TO: Mayor Robert Price, City of Locust Grove
ATTN TO: Anna Ogg, Planner II, City of Locust Grove
FROM: Mike Alexander, Director, ARC Center for Livable Communities
RE: Development of Regional Impact (DRI) Review

Name of Proposal: Sansone Speculative Industrial Development DRI 3506

Description: A Development of Regional Impact Review of a proposal to build 882,000 SF of industrial space in three one-story buildings on a 113.6 acre site located between I-75 on the west and SR 42 on the east at the intersection of SR 42 and Pine Grove Road in the city of Locust Grove in Henry County. The currently undeveloped site is mostly forested and includes a number of streams and floodplains. The project will allocate 20.37 acres for the three buildings, 44.13 acres for parking and driveways, 44.13 acres for open space, and 4.53 acres for stream/floodplain buffers..

DRI# 3506 SANSONE
SR42 LOCUST GROVE
SR42 AND PINE GROVE RD
JANUARY 10, 2022

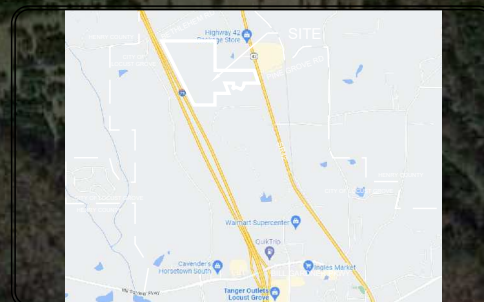
Two intermittent blue line streams cross the property and flow into a tributary of Indian Creek to the west. The 50-foot buffer and 75-foot impervious setback required by the Locust Grove Stream Buffer Ordinance are shown on plans but the 25-foot State buffer is not shown; all applicable buffers should be shown. Driveways and parking areas around Building A intrude into stream buffers and may require City variances.

An internal sidewalk network will connect to SR 42 general pedestrian access, but no sidewalk is proposed along SR42; a sidewalk along the property frontage would be supportive of basic regional multi-modal transportation policies.

Both the USGS coverage for the project area and the project site plan show two intermittent blue line streams crossing the property and flowing into an unnamed tributary of Indian Creek off-site on the west side of I-75. Three short branches off the southernmost tributary are also shown on the submitted site plan that are not shown on the USGS coverage. The site plan shows the 50-foot buffer and 75-foot impervious setback required by the Locust Grove Stream Buffer Ordinance on all the mapped streams. However, the 25-foot State Erosion and Sedimentation Act buffer is not shown. The proposed site plan includes intrusions into the buffers of three of branches of the southernmost stream. All are intrusions by driveways or parking areas surrounding the proposed Building A, and may require variances under the Locust Grove Stream Buffer Ordinance.

Both the USGS coverage for the project area and the project site plan show two intermittent blue line streams crossing the property and flowing into an unnamed tributary of Indian Creek off-site on the west side of I-75. Three short branches off the southernmost tributary are also shown on the submitted site plan that are not shown on the USGS coverage. The site plan shows the 50-foot buffer and 75-foot impervious setback required by the Locust Grove Stream Buffer Ordinance on all the mapped streams. However, the 25-foot State Erosion and Sedimentation Act buffer is not shown. The proposed site plan includes intrusions into the buffers of three of branches of the southernmost stream. All are intrusions by driveways or parking areas surrounding the proposed Building A, and may require variances under the Locust Grove Stream Buffer Ordinance.

The 25-foot State Erosion and Sedimentation Act buffer should be shown on all the mapped streams. Any unmapped streams on the property may also be subject to the Locust Grove Stream Buffer Ordinance as well as the 25-foot State Erosion and Sedimentation Act buffer. Any unmapped waters of the state on the property will also be subject to the 25-foot State Erosion and Sedimentation Act buffer.
